# CERTIFICATE OF APPROPRIATENESS PLACARD

Remove rear ramp; construct rear ramp

COA-0136-2021

CLIENT: SIERRA STRUCTURES  
PROJECT: CARTER - ADA RAMP REBUILD  
LOCATION: 412 MORSON STREET, RALEIGH, NC

**GUARD SECTION W/ HANDRAIL**  
SCALE: 1" = 1'-0"

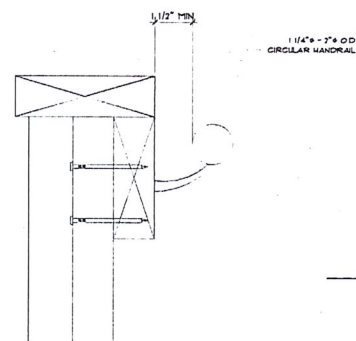
6. Although the existing railing posts and pickets are bolted/nailed through the face of the trim, this attachment detail does not clearly meet the Design Guidelines and cannot be approved by staff. Fences and railings should be constructed with a neighbor-friendly design, so that structural members face inward or the appearance is the same on both sides of the railing. See attached for an example image of an approvable inset railing detail. Would you consider amending your application to remain a minor work? Please provide updated materials if so. **Revised Drawing Attached**

1. Please format scaled drawings to a maximum size of 11x17. All information should be legible when printed at that scale.
2. It appears that the proposed rear ramp will be installed in the same footprint, dimensions, and configuration as the existing ramp to be removed – is that correct?
3. Trex is approvable as a new ramp surface; how will the material be oriented on the framing? Will any cut ends be exposed?
4. Will the proposed ramp be screened from below? If so, with what material? The openings under the ramp should be screened to be considered clearly congruous with the RHDC's [Design Guidelines](#).
5. Although the existing railing posts and pickets are bolted/nailed through the face of the trim, this attachment detail does not clearly meet the Design Guidelines and cannot be approved by staff. Fences and railings should

be constructed with a neighbor-friendly design, so that structural members face inward or the appearance is the same on both sides of the railing. See attached for an example image of an approvable inset railing detail. Would you consider amending your application to remain a minor work? Please provide updated materials if so.

## Plan View

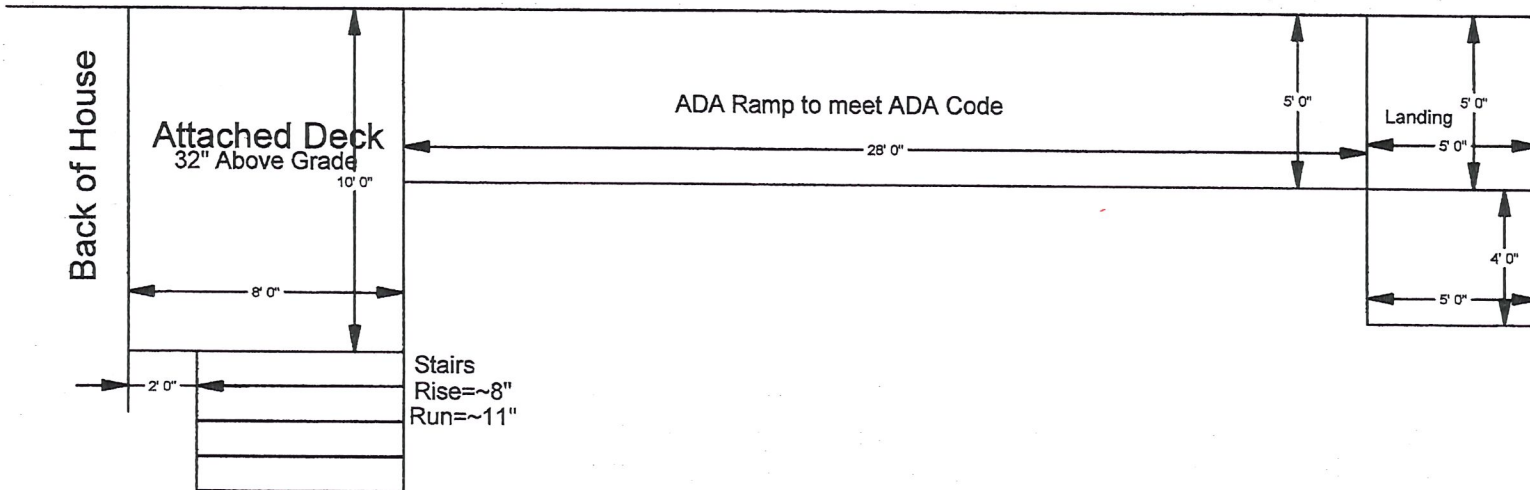
3. It appears that the proposed rear ramp will be installed in the same footprint, dimensions, and configuration as the existing ramp to be removed – is that correct? **YES**
